**ADDENDUM
NO. 7**

June 9, 2022

**Greenfield Central High School Auditorium Renovation and
Addition – Bid Package No. 2
810 N. Broadway
Greenfield, IN 46140**

LIFE SAFETY PLAN - FIRST FLOOR

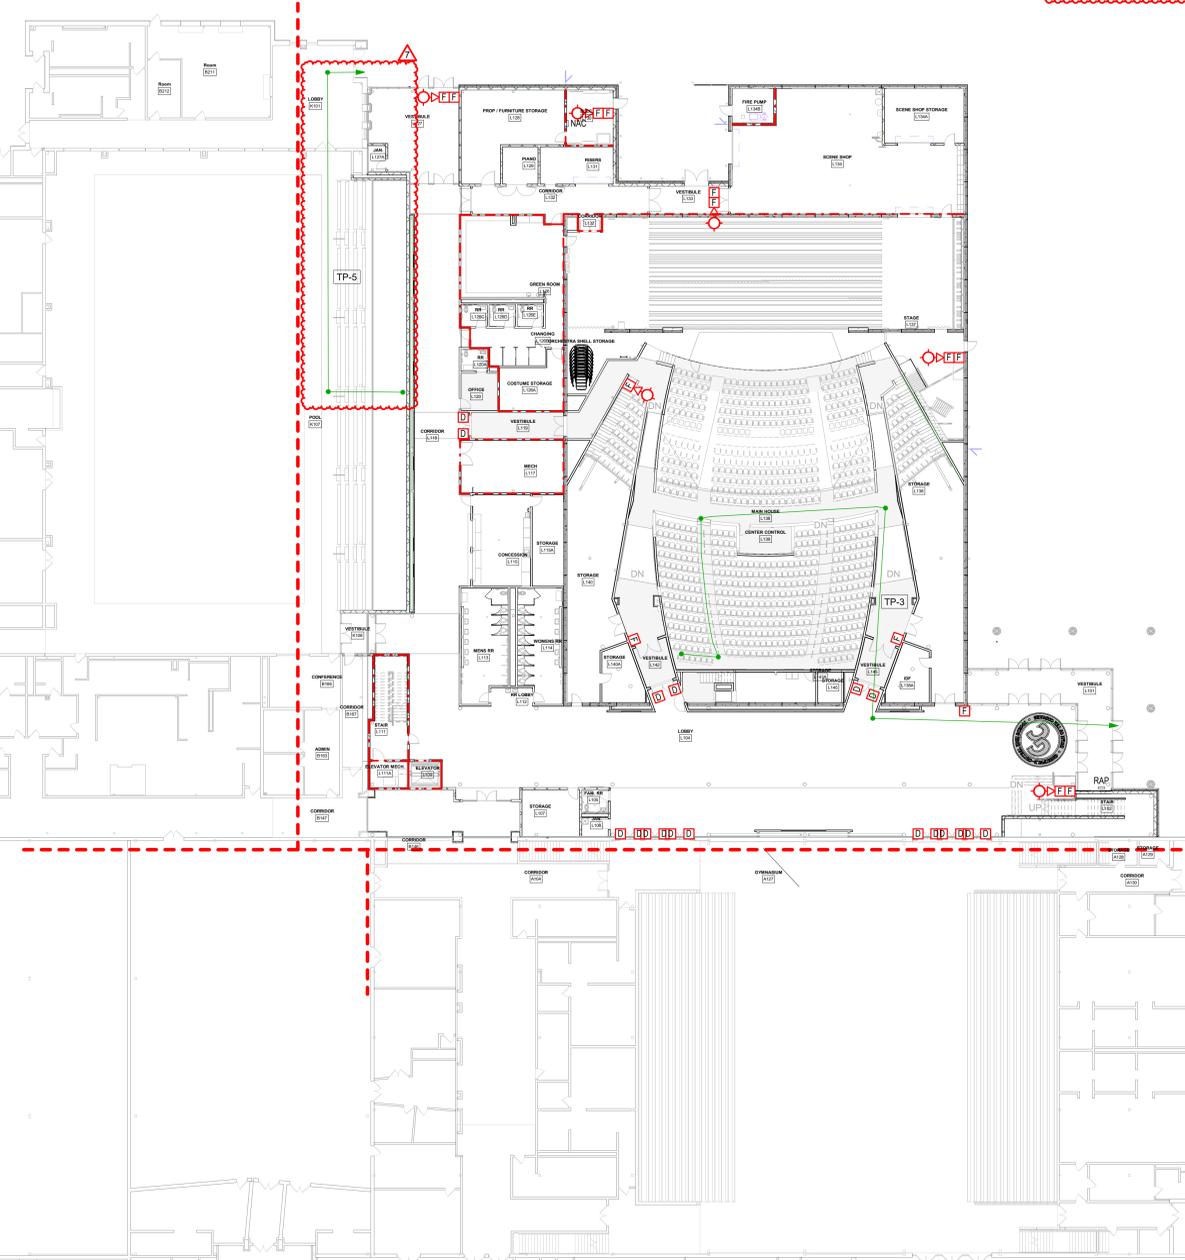
1. LS001
 - TP-4 [DELETED]
 - TP-5 ADDED
 - REVISED PATH OF TRAVEL SCHEDULE
2. A402
 - REVISED DETAIL 2/A402
3. A511
 - REVISED DETAIL 7/A511
4. A515
 - REVISED DETAIL 1/A515
 - REVISED DETAIL 2/A515
 - REVISED DETAIL 7/A515
5. A720
 - RB-3 ADDED
 - CON-1 REVISED
 - CON-2 REVISED
6. A721L
 - FINISH PLAN NOTE 23 ADDED
7. A722L
 - REVISED L202 FINISH TAG

FOUNDATION PLAN - UNIT L

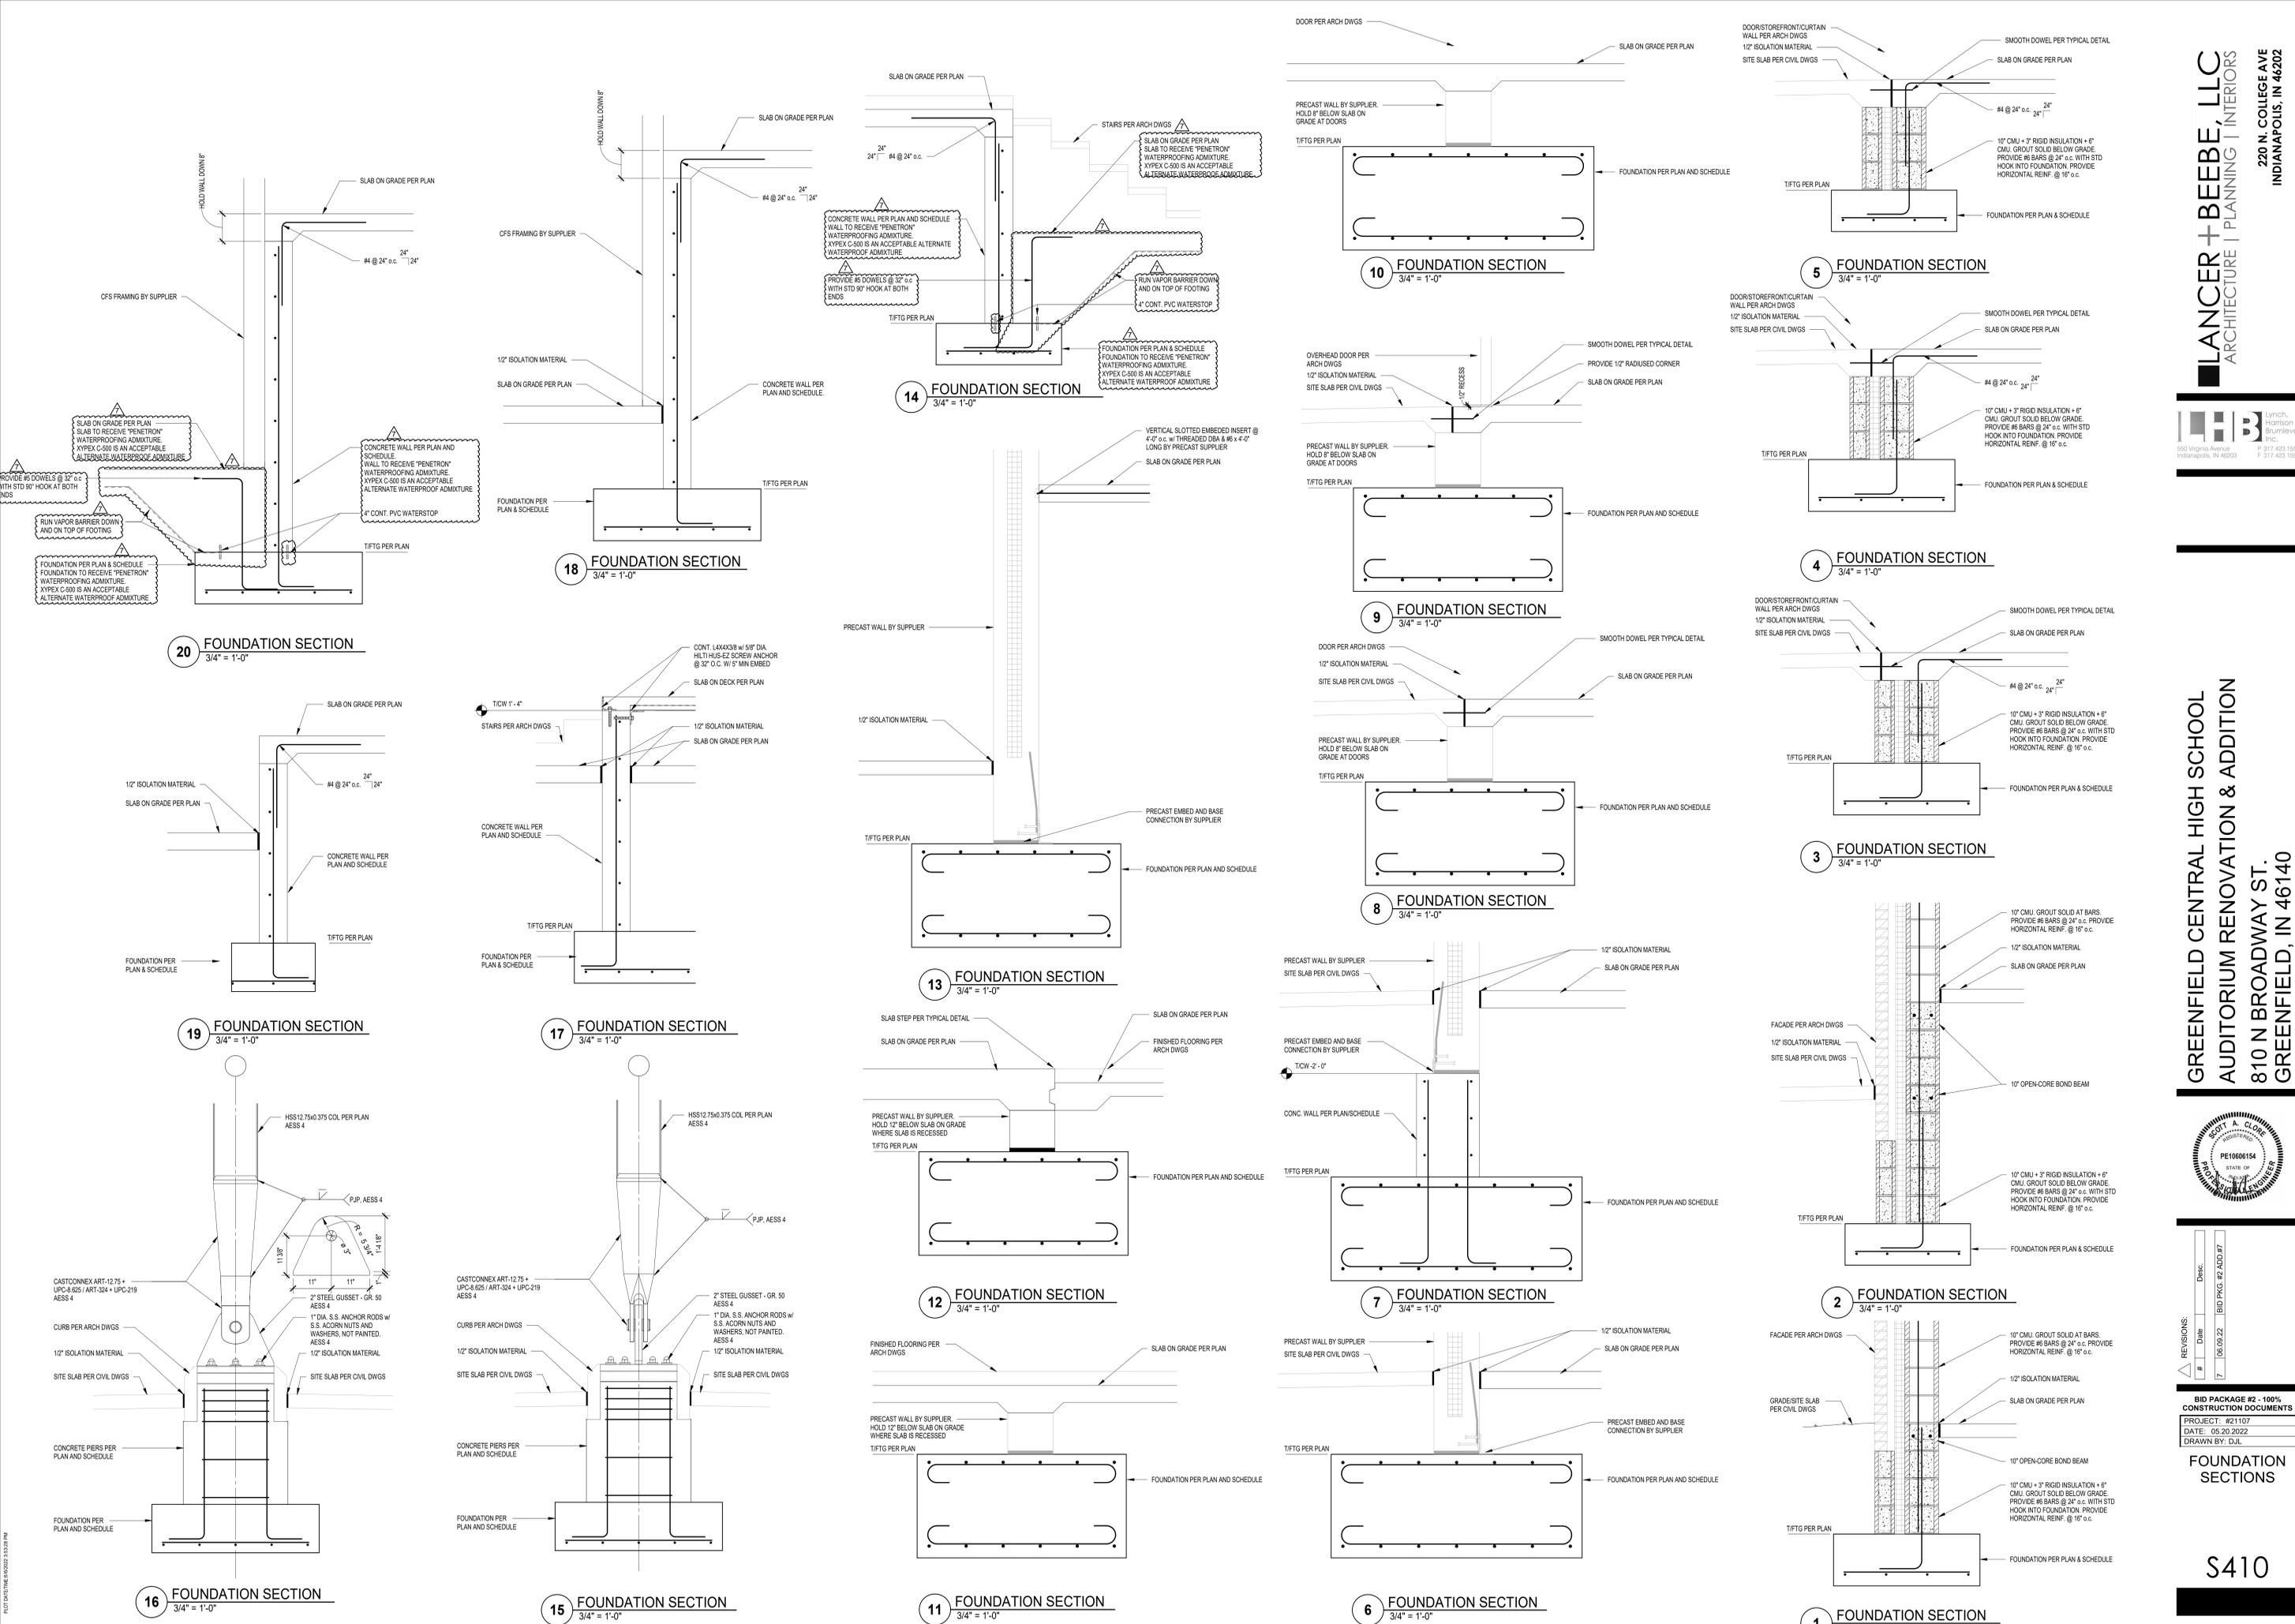
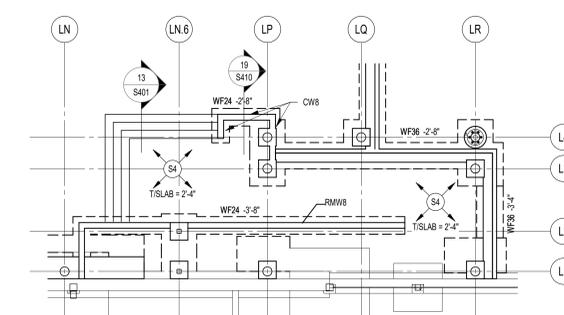
1. S101L – Foundation Plan – Unit L
 - Added section for elevator pit footing
2. S201 – Enlarged Auditorium Foundation Plan
 - Adjusted orchestra pit and sloping slab approaching pit
3. S401 – Typical Foundation Sections
 - Adjusted detail 3
4. S410 – Foundation Sections
 - Adjusted detail 14
 - Added detail 20
5. S411 – Foundation Sections
 - Adjusted details 5 & 6

INTERIOR
FINISH PLAN -
FIRST FLOOR -
UNIT L

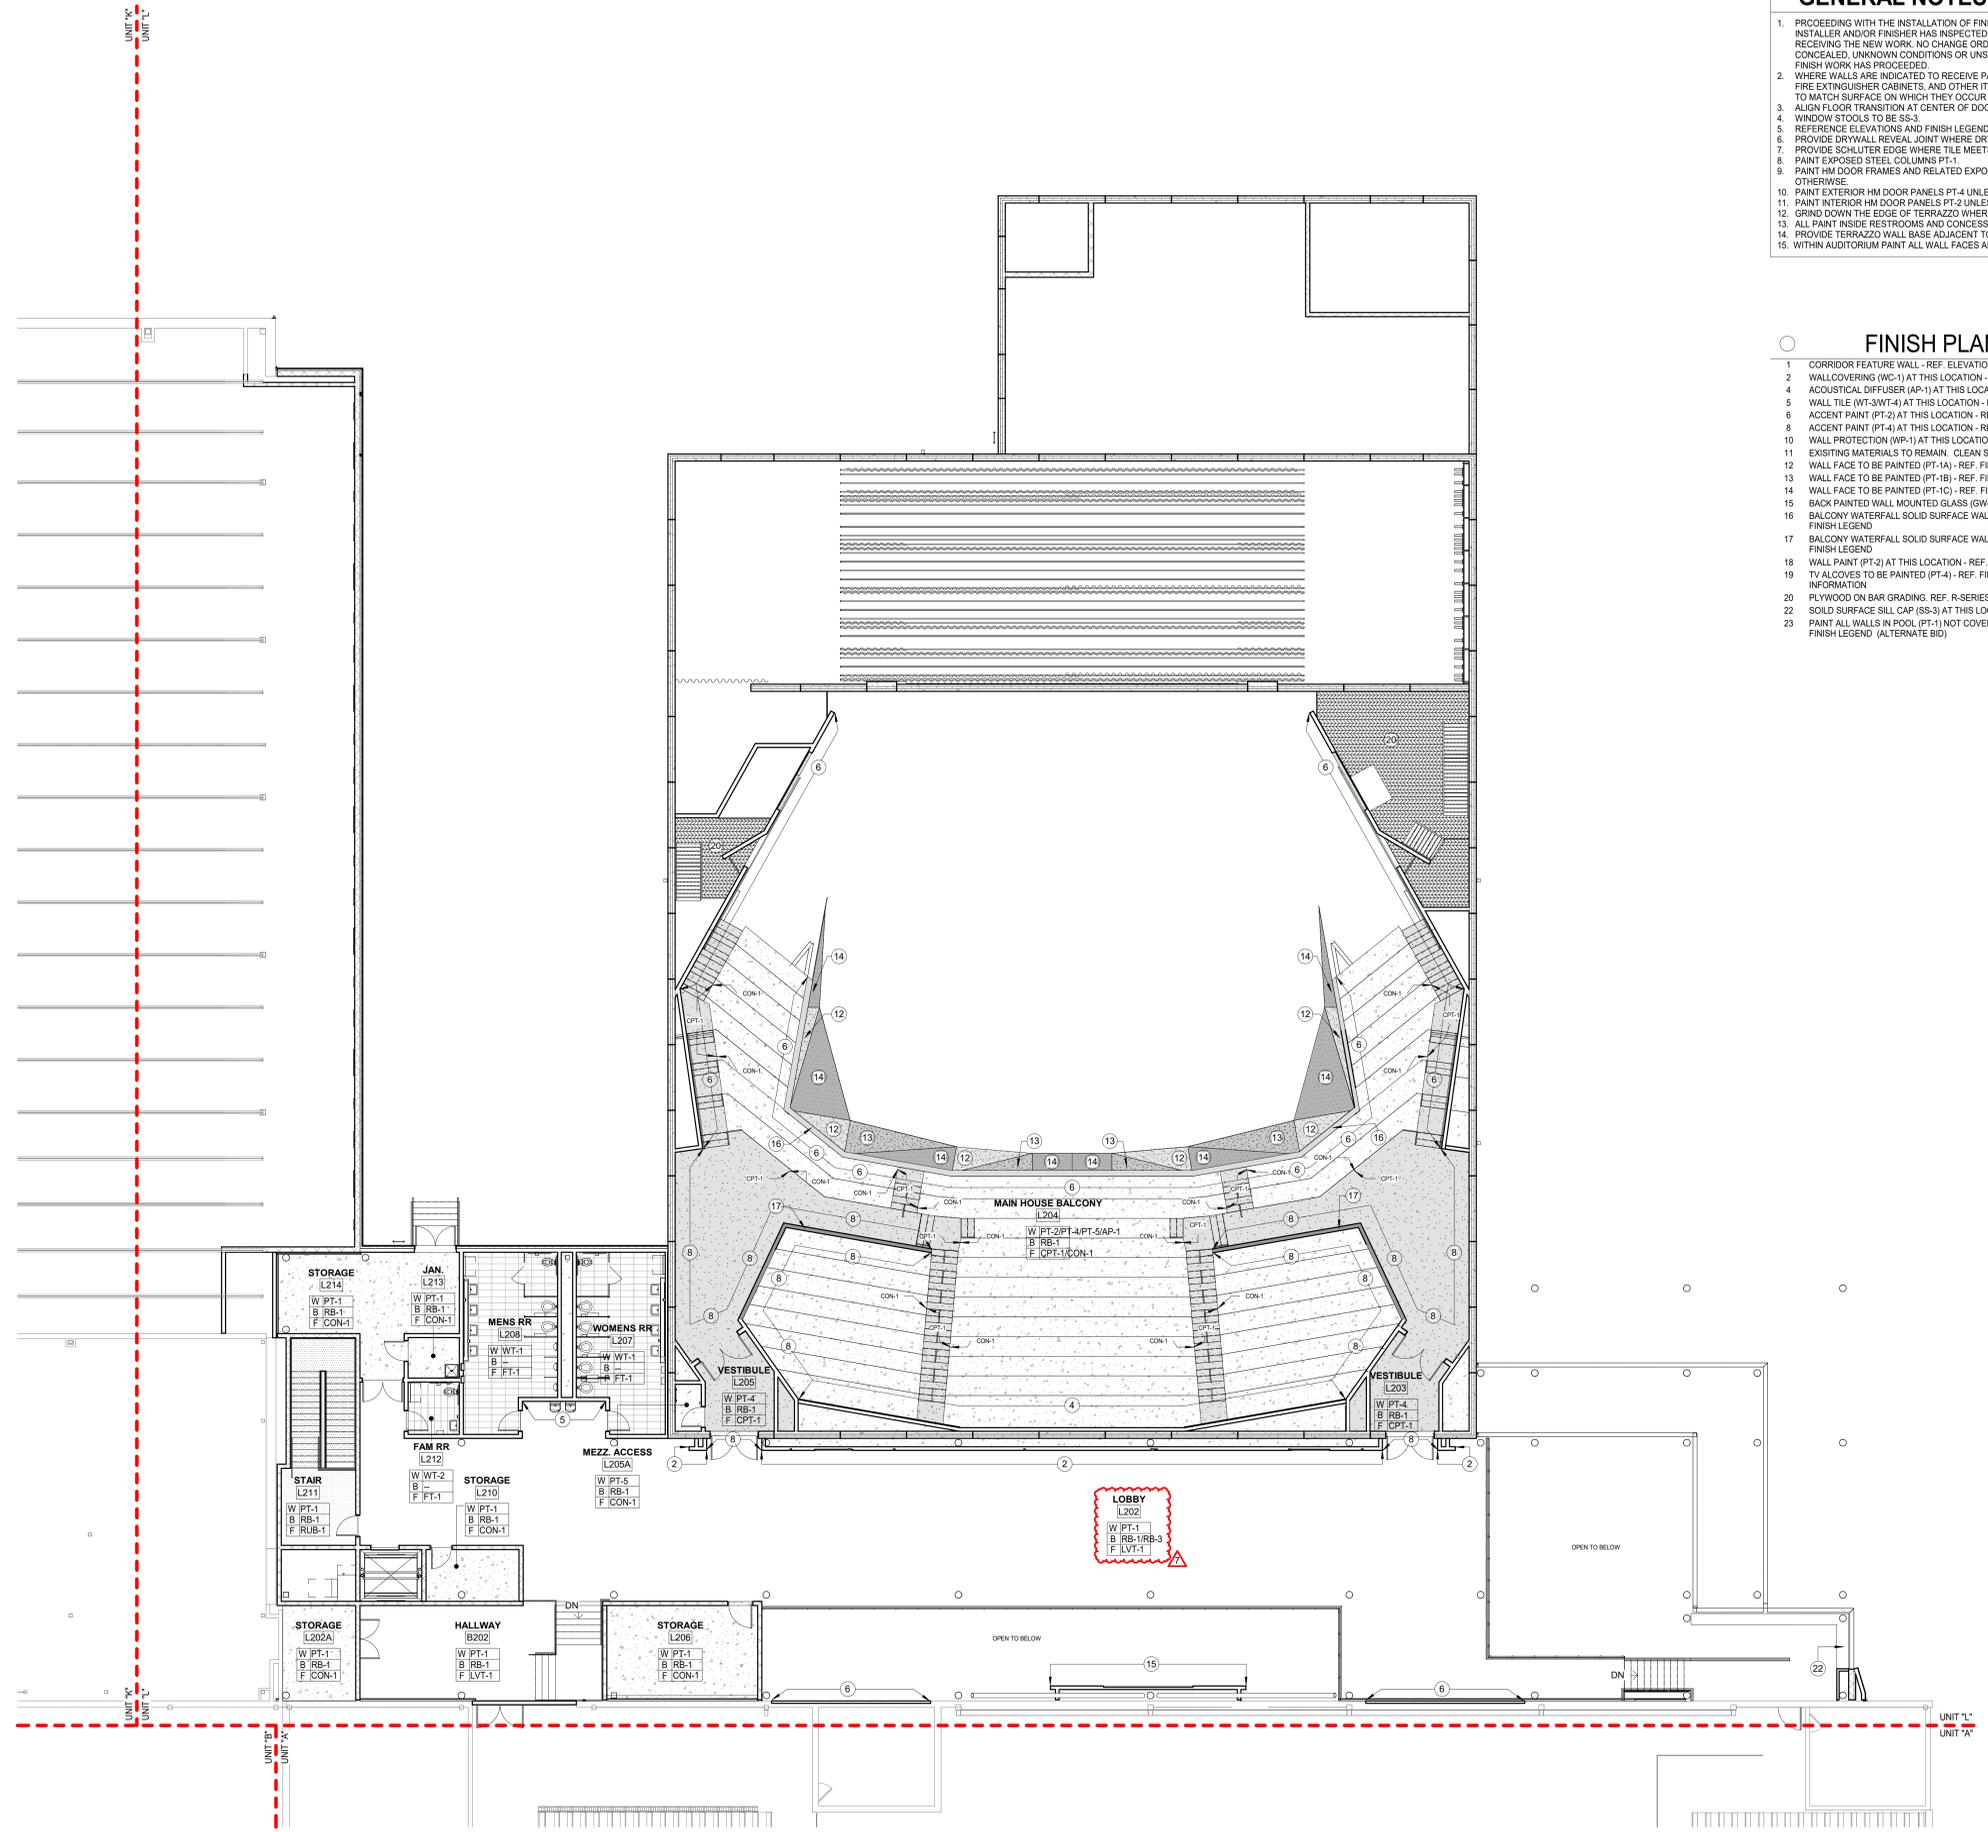
- H. ALTERNATE NO. 8: NATATORIUM PAINTING
1. Base Bid: Paint walls indicated by Key Note 6 on Sheet A721L.
2. Alternate: State cost to provide materials, labor, and equipment to paint the existing Natatorium walls per Key Note 23 on Sheet A721L.

20. PLYWOOD ON BAR GRADING - REF. R-SERIES FOR ADDITIONAL INFORMATION
22. SOLID SURFACE SILL CAP (SS-3) AT THIS LOCATION - REFER TO FINISH LEGEND
23. PAINT ALL WALLS IN POOL (PT-1) NOT COVERED BY FINISH PLAN NOTES - REFER TO FINISH LEGEND (ALTERNATE BID)
